Comment Form: Scoping
Energy Environmental Review and Analysis

Please share your comments on the proposed Rochester Natural Gas Pipeline Project (15-858)

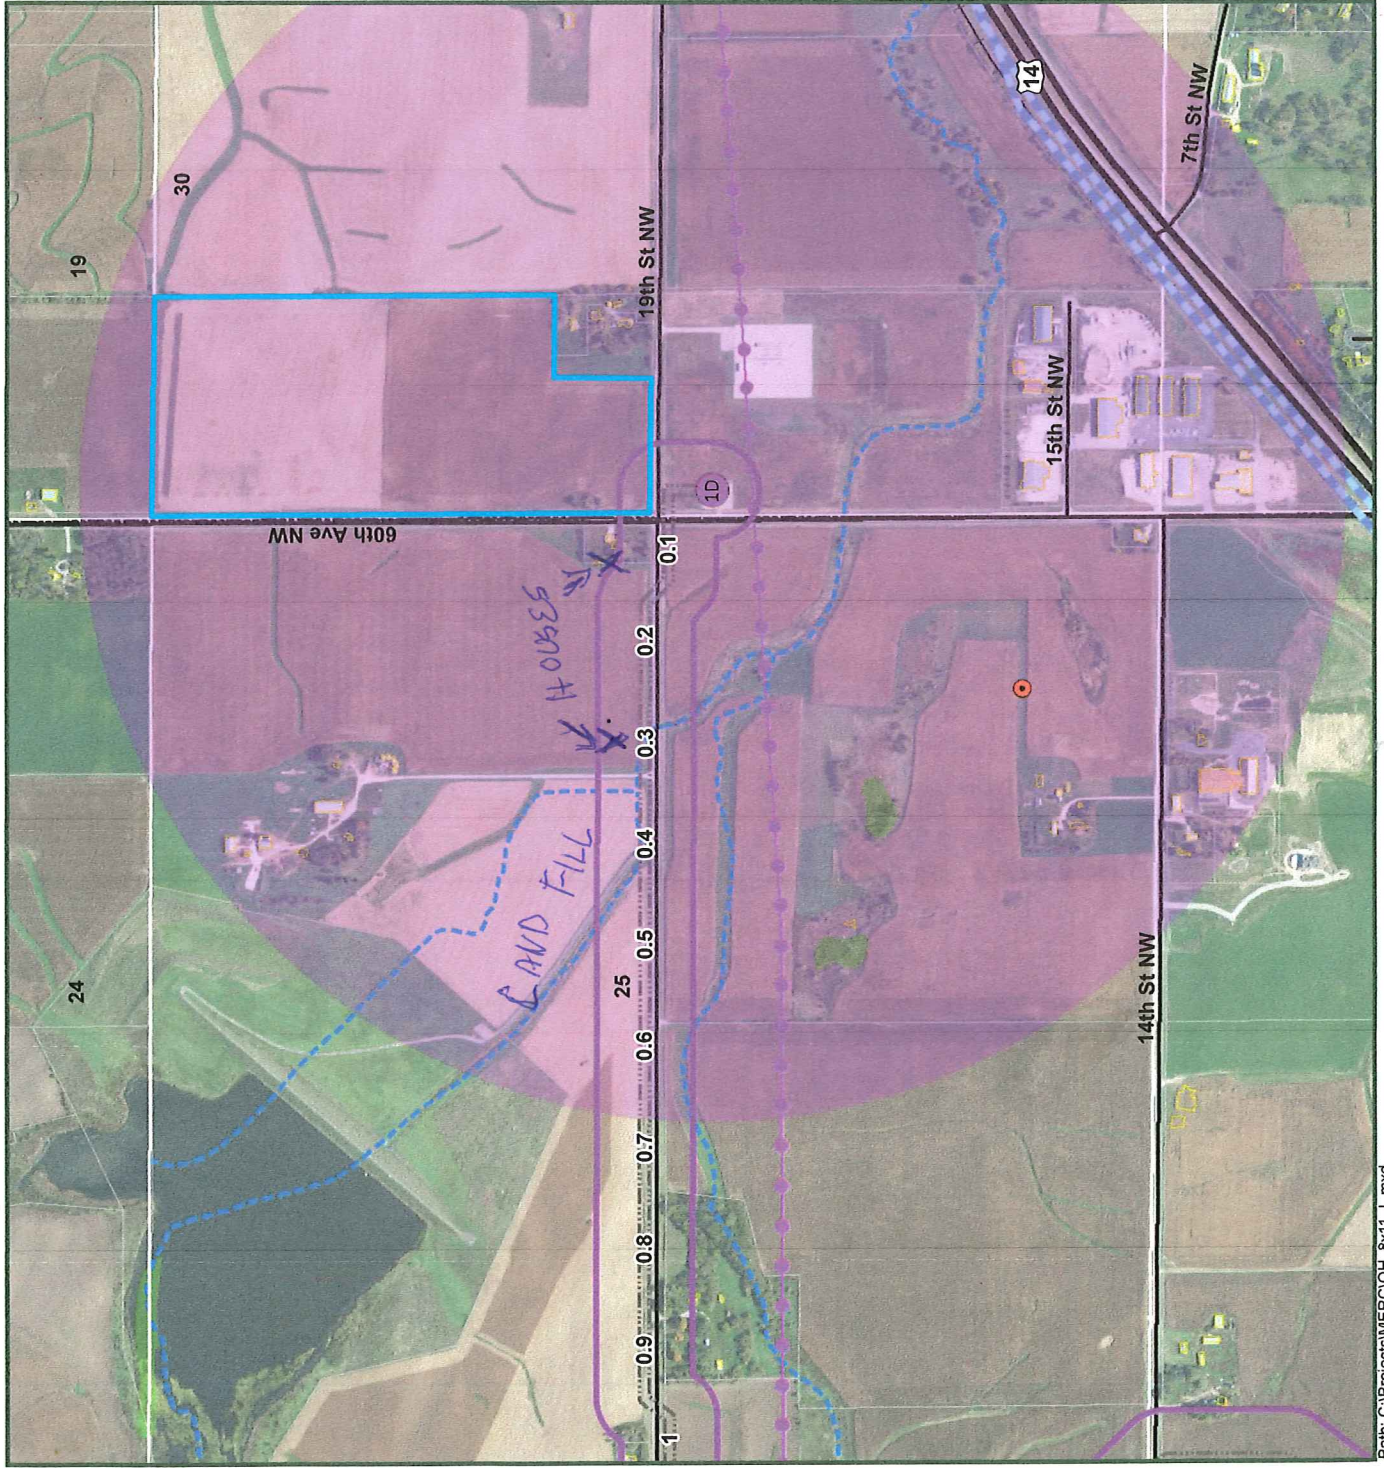
Recommend following existing pipeline that parallels 19th St. NW in Section 25 near North Town Border Station, and (between 60th Ave + 70th Ave).

The location of the proposed new line on this map proceeds north of 19th St. and crosses over lawns of 2 occupied homes and very close to the "Olmsted County Landfill". Then it must katti-corner both 60th Ave + 19th St. to get to the North Town Border Station. If it followed existing pipeline, it would use a g. land (with lots of room) and only deal with crossing 60th Ave NOT 19th St.
